SUBJECT: DRESDEN NUCLEAR POWER STATION, UNITS 2 AND 3 – STAFF
ASSESSMENT OF FLOOD HAZARD INTEGRATED ASSESSMENT
(CAC NOS. MG0221 AND MG0222; EPID L-2017-JLD-0050)

STAFF ASSESSMENT BY THE OFFICE OF NUCLEAR REACTOR REGULATION
RELATED TO THE INTEGRATED ASSESSMENT
FOR DRESDEN NUCLEAR POWER STATION, UNITS 2 AND 3
AS A RESULT OF THE REEVALUATED FLOODING HAZARD
NEAR-TERM TASK FORCE RECOMMENDATION 2.1 - FLOODING
CAC NOS. MG0221 AND MG0222, EPID L-2017-JLD-0050

Figure 3.3.5-1 Rating Curves at the Dresden Site.

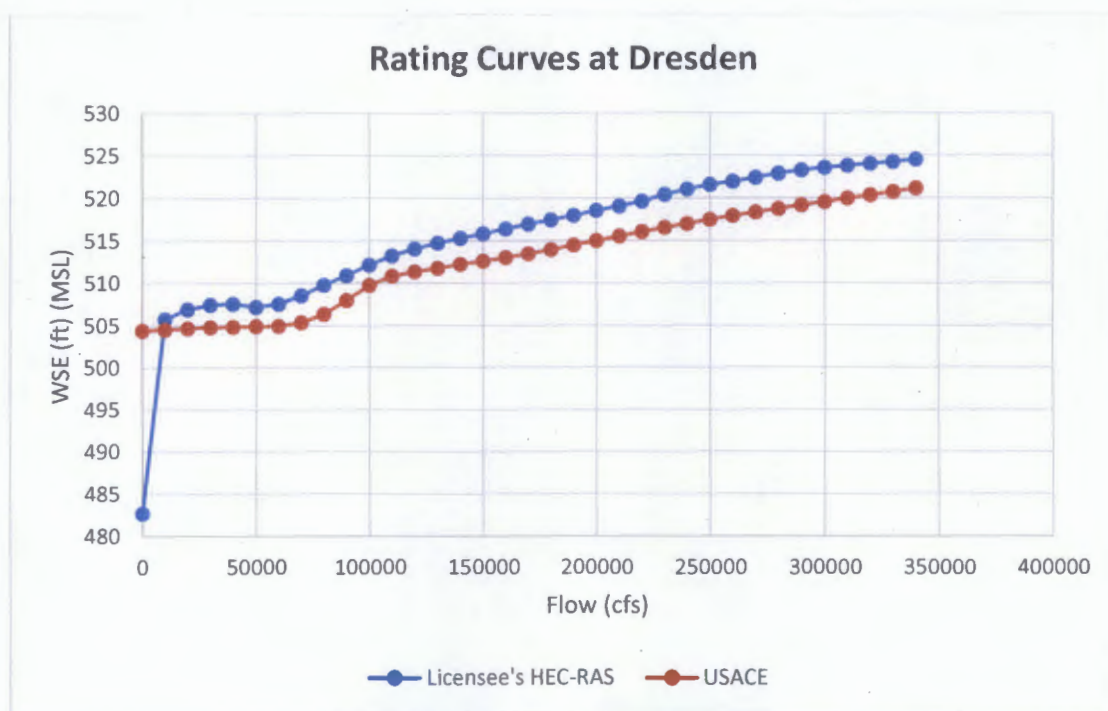
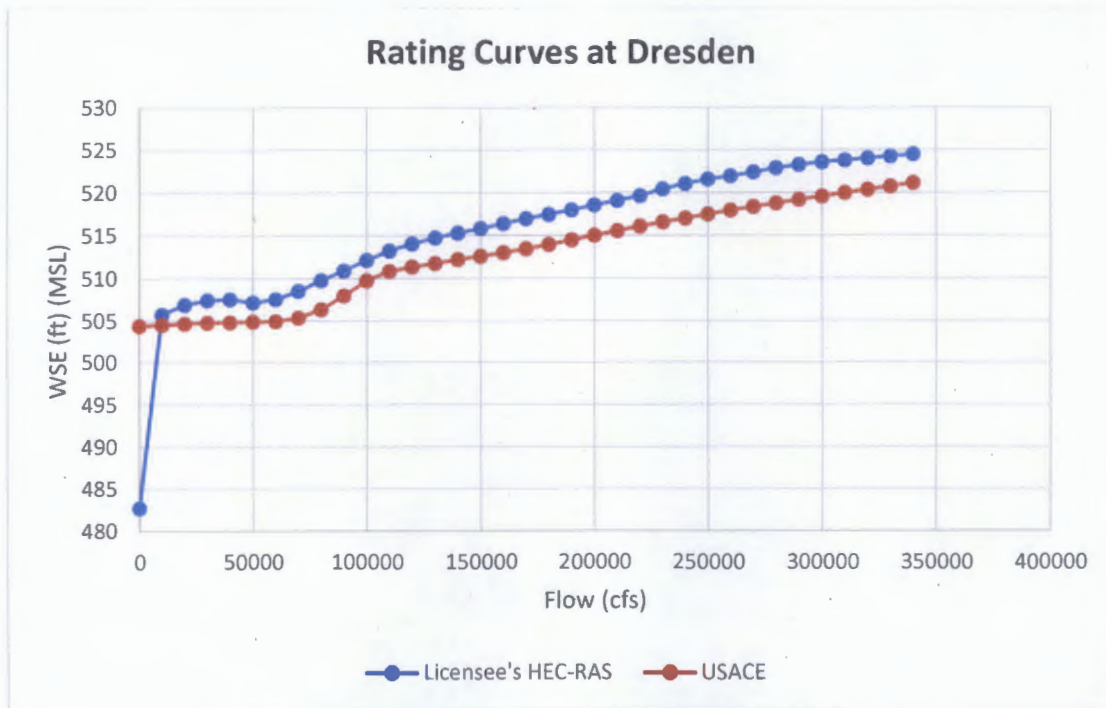
The staff generated a rating curve using the licensee's HEC-RAS model and compared this curve to the rating curve from flood frequency studies performed by the USACE for the region⁴. The NRC staff found the curve generated from the licensee's HEC-RAS model to be appropriate for use in the staff's independent analysis. The NRC staff used flow rates from the modified HEC-HMS models along with this rating curve to estimate the flood elevations for each scenario (Figure 3.3.5-1).
